PLANNING REVIEW

180 EL CAMINO REAL, BLDG D, SUITE #136B
STORE NO. TBD,
LEVEL: GROUND LEVEL
PALO ALTO, CA 94304

SUBMITTAL
PLANNING REVIEW 2/26/24

DELAROSA
180 EL CAMINO REAL,
BLDG D,
SUITE #136B
PALO ALTO, CA 94304

PROPOSED RCP
Scale: 1/4" = 1'-0"

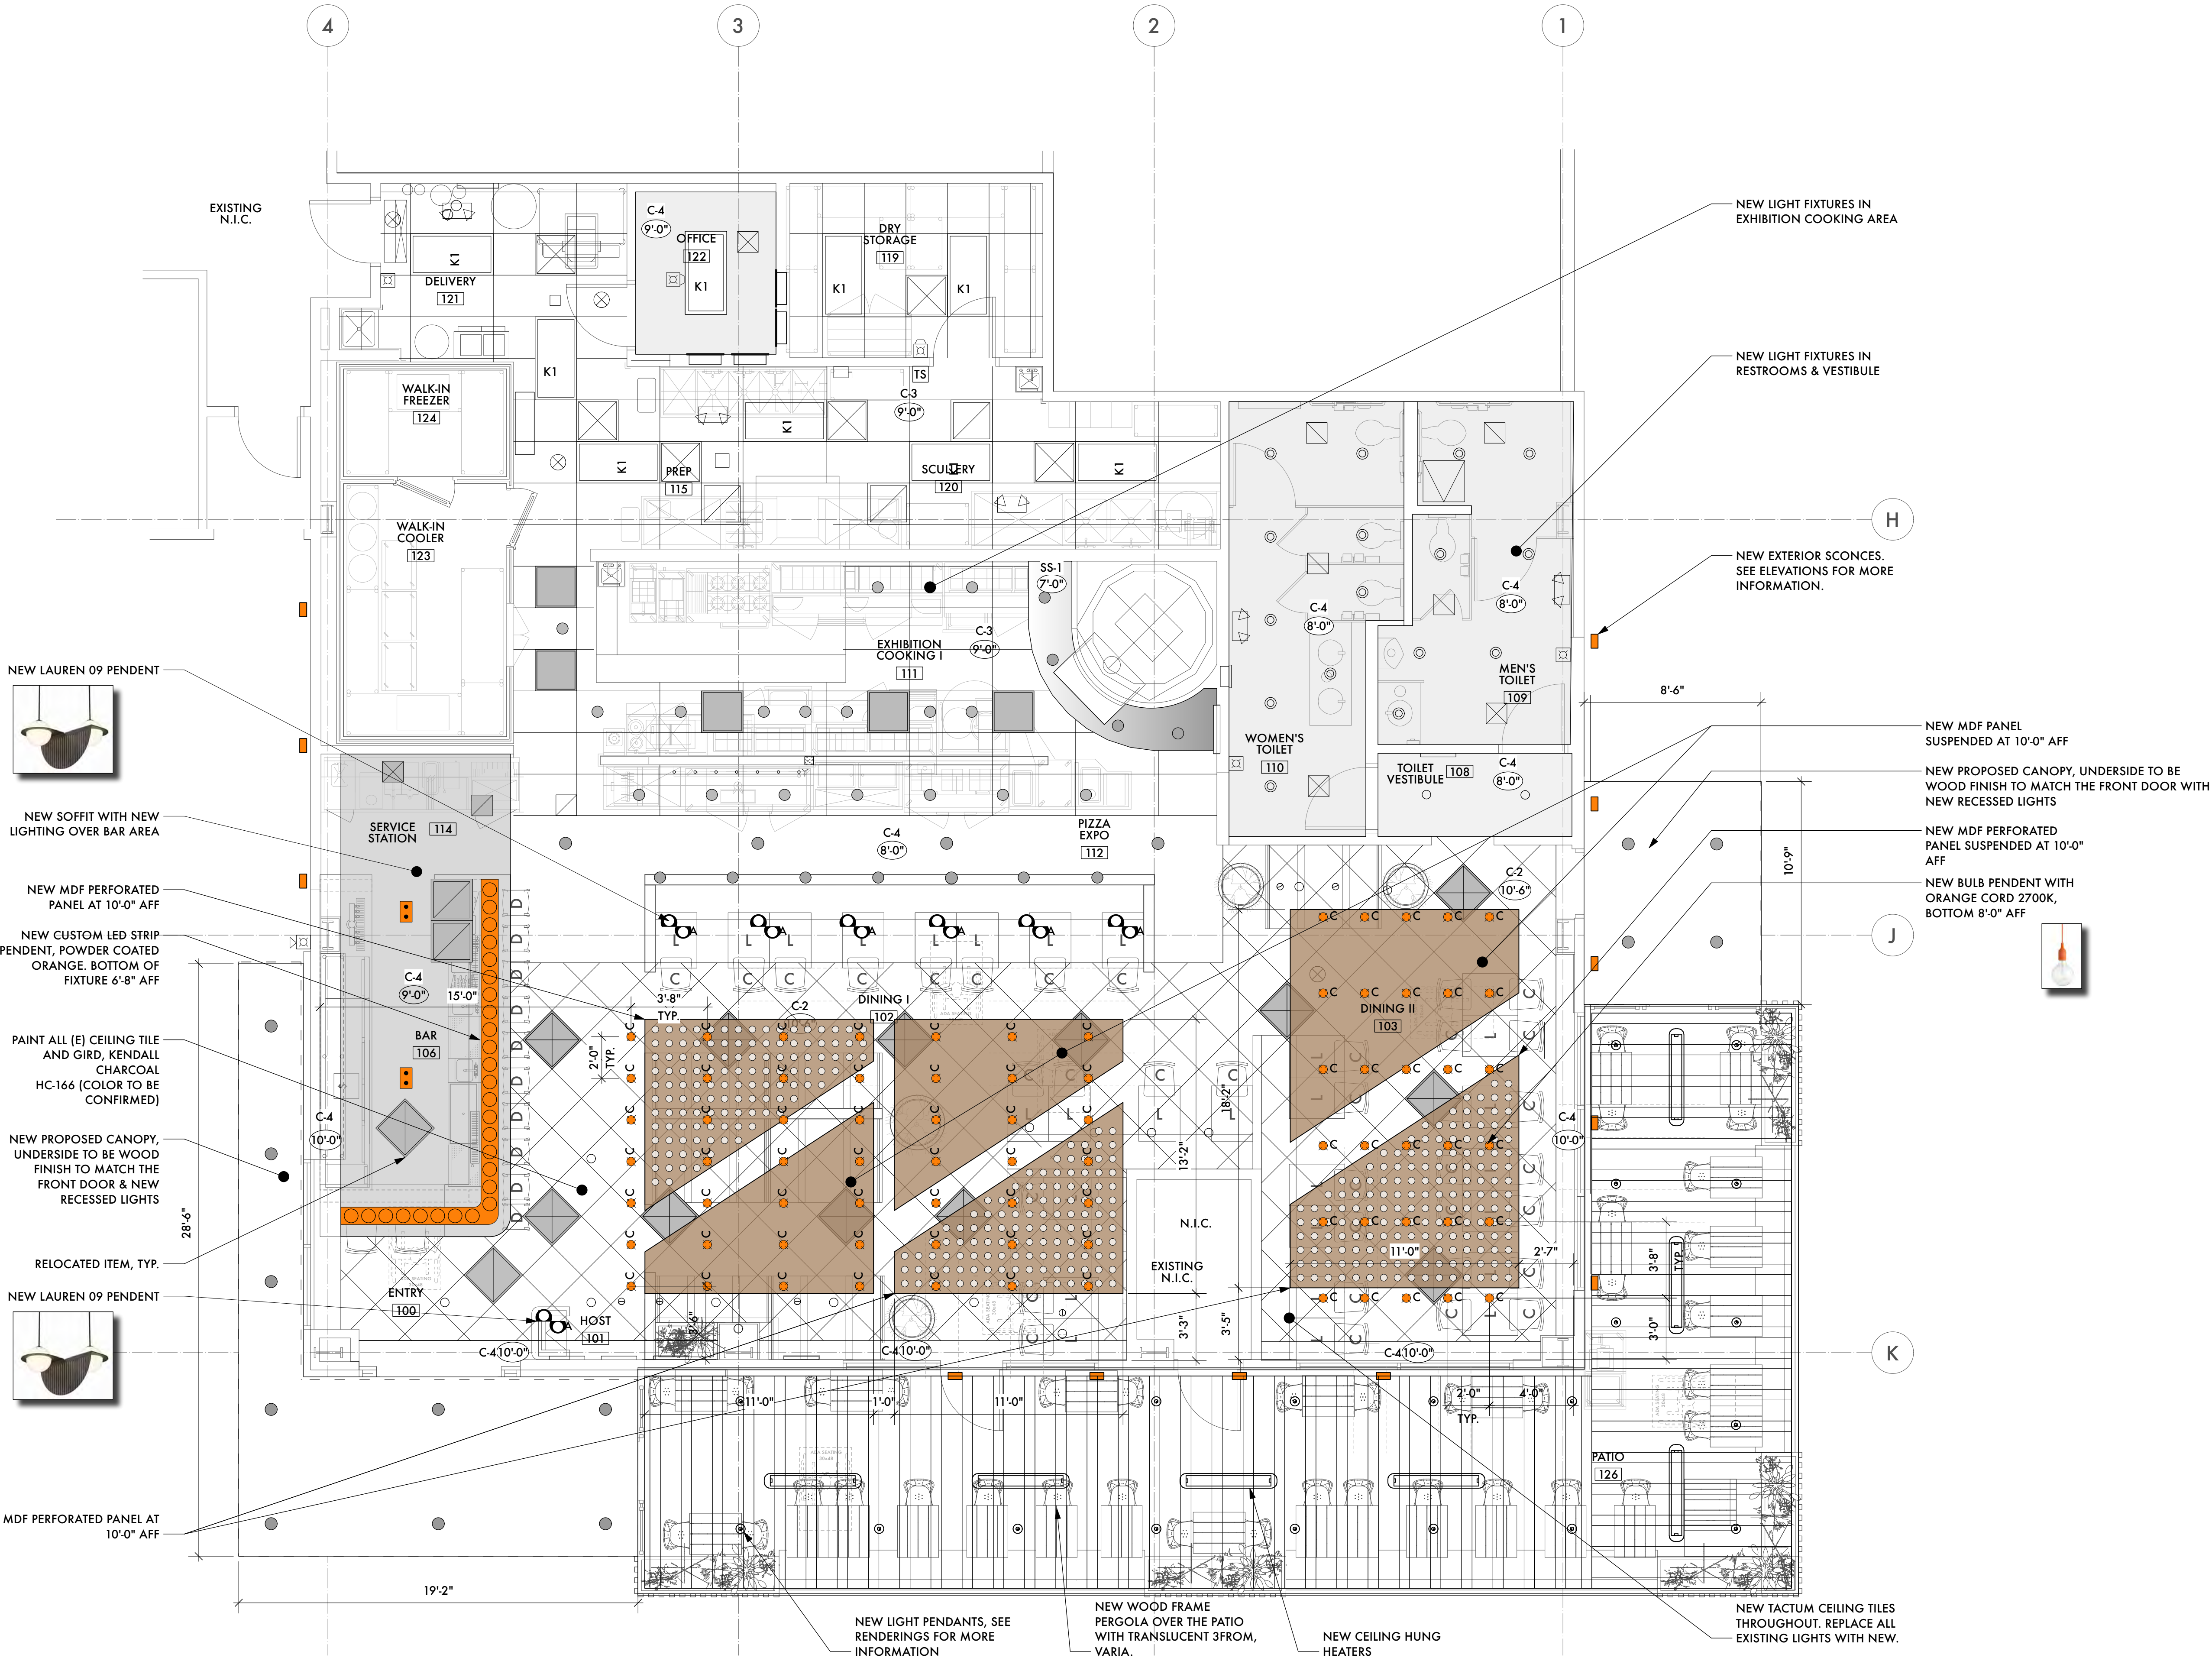
REFLECTED CEILING PLAN COMMENTS:

- IF NOT ALREADY EXISTING, TENANT MUST PROVIDE A SEALED PARTITION ABOVE THE STOREFRONT TO SEPARATE THE COMMON AREA CEILING FROM THE TENANT'S SPACE. (SHALL BE RATED IF REQUIRED BY CODE AND ALL PENETRATION SHALL COMPLY AND BE LABELED WITH THE REQUIRED NFPA RATING.)

- NOTHING IS PERMITTED TO BE ATTACHED TO, SUSPENDED FROM, OR PENETRATE LANDLORD'S STRUCTURE, FLOOR DECK, OR ROOF DECK. YOU MAY ATTACH, NON-DESTRUCTIVELY, TO OR SUSPEND FROM THE TOP CHORD OF THE JOIST OR THE STRUCTURAL STEEL WHICH EXISTS ABOVE THE TENANT SPACE. WHEN ATTACHING TO LANDLORD'S STRUCTURE, DO NOT DRILL, WELD, SCREW, OR SHOOT INTO STRUCTURE. ALTERNATIVE METHODS OF ATTACHMENT ONLY, NOTHING TO DAMAGE LANDLORD'S BASE BUILDING STRUCTURE. TENANT SHALL PROVIDE SIGNED AND SEALED STRUCTURAL DRAWINGS, BY A STRUCTURAL ENGINEER WITH LEGALLY ACTIVE REGISTRATION AS INDICATED BY ALL JURISDICTIONAL REQUIREMENTS, FOR ALL STRUCTURAL MODIFICATIONS FOR LANDLORD RECORDS.

- ANY LANDLORD EQUIPMENT, COMPONENT, AND / OR SERVICE FEEDING OTHER TENANT(S) THAT IS EXISTING IN THE SPACE MUST REMAIN VISIBLE AND ACCESSIBLE TO THE LANDLORD. TENANT SHALL INSTALL ACCESS PANELS AS REQUIRED TO MAINTAIN ACCESS. ACCESS PANELS SHALL BE LABEL TO PROPERLY IDENTIFY SYSTEM, COORDINATE WITH MALL OPERATIONS.

- SIMON REQUIRES ALL TENANTS TO USE LANDLORD'S REQUIRED CONTRACTOR FOR ALL SPRINKLER WORK. REFER TO SPRINKLER COMMENTS FOR FURTHER REQUIREMENTS.

SECURITY CAMERA COMMENTS:

- SECURITY EQUIPMENT MUST BE INSTALLED WITHIN THE PREMISES; CAMERAS AND/OR SECURITY EQUIPMENT ARE NOT PERMITTED ON THE EXTERIOR OF THE PREMISES UNLESS APPROVED IN WRITING BY LANDLORD. HOWEVER, IN CASES WHERE LANDLORD APPROVES EXTERIOR CAMERAS OR EQUIPMENT, THE CAMERAS OR EQUIPMENT SHOULD BE POSITIONED AS TO LIMIT VIEWING AREA AND SHALL CAPTURE IMAGES OF THE TENANT'S DOORWAYS ONLY AND SHALL NOT CAPTURE IMAGES OUTSIDE OF THE PREMISES. IN CASES WHERE A TENANT MAY HAVE AN APPROVED PATIO AREA, ALL CAMERAS OR EQUIPMENT SHALL BE INSTALLED AND OPERATED SO AS TO CAPTURE ONLY THE APPROVED PATIO AND NO COMMON AREA.

- ALL EQUIPMENT, INSTALLATION METHODS AND LOCATIONS MUST BE APPROVED BY LANDLORD IN WRITING PRIOR TO INSTALLATION.

- NO SIGNAL SHALL BE EMITTED OUTSIDE THE PREMISES.

- ABSOLUTELY NO DISTRIBUTION, ELECTRONICALLY OR OTHERWISE, OF CAPTURED IMAGE OR VIDEO TO ANY THIRD PARTY OTHER THAN LANDLORD UPON REQUEST.

- SECURITY CAMERAS, VISION PANELS, OR "BUBBLES" SHALL NOT BE VISIBLE TO PUBLIC VIEW IN THE DESIGN CONTROL ZONE OR ON PATIOS FROM THE COMMON AREA.
